This page lists the know errors on the gm5x5x5 PCBs. There are no known issues with the bulk order run (white pcbs), the following information is valid **only** for the prototype run (green pcbs).

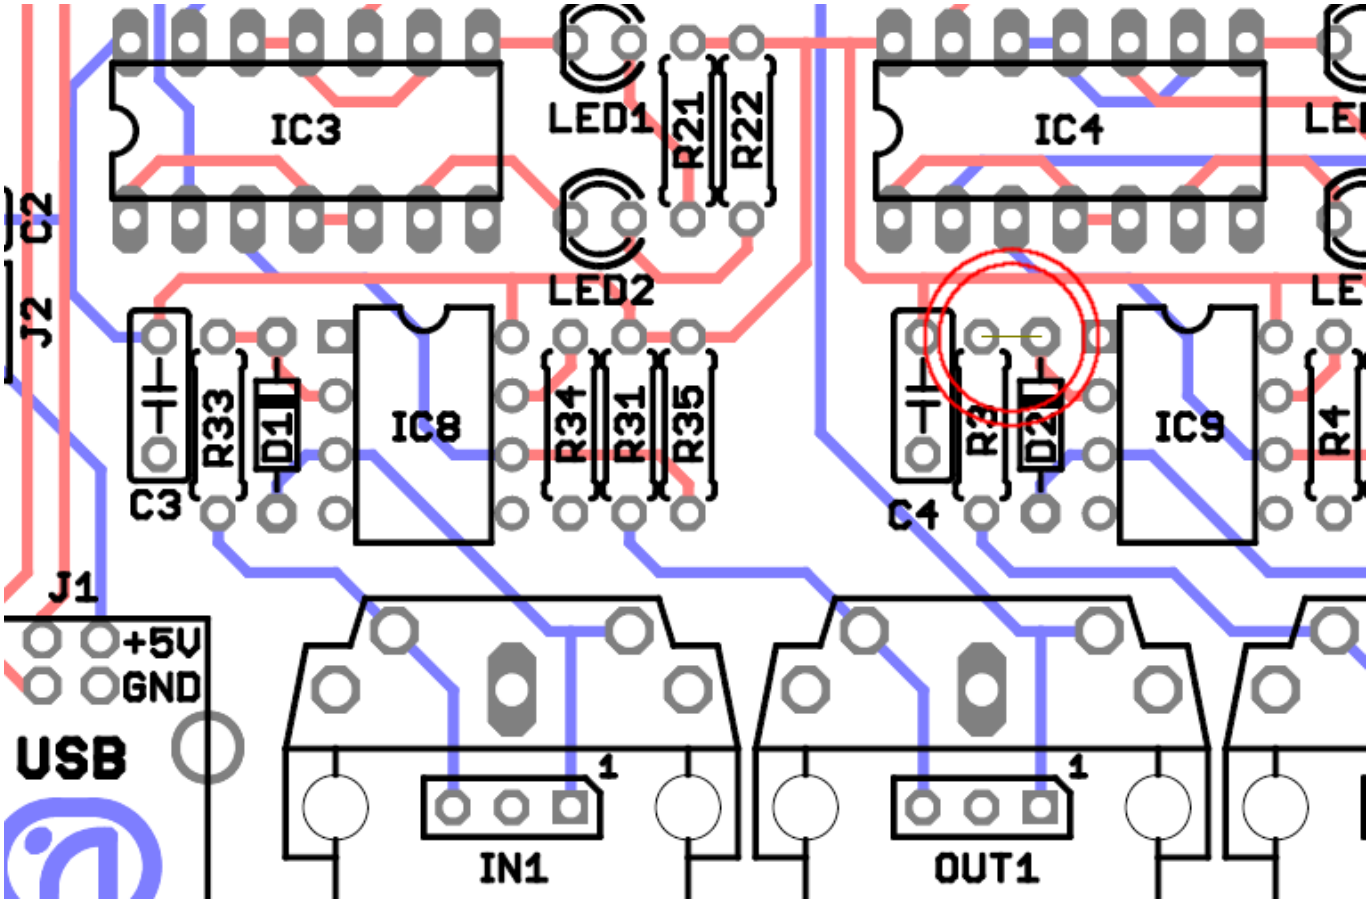
Problem: The MIDI IO pins of the midi sockets (Pin 4 + 5) are switched.

Solution: Either (1) use the pin-headers if you use sockets that are not mounted on the pcb or (2) break the traces to pins 4 + 5 of the sockets and solder wires to them or (3) solder the midi sockets on the other side of the pcb.
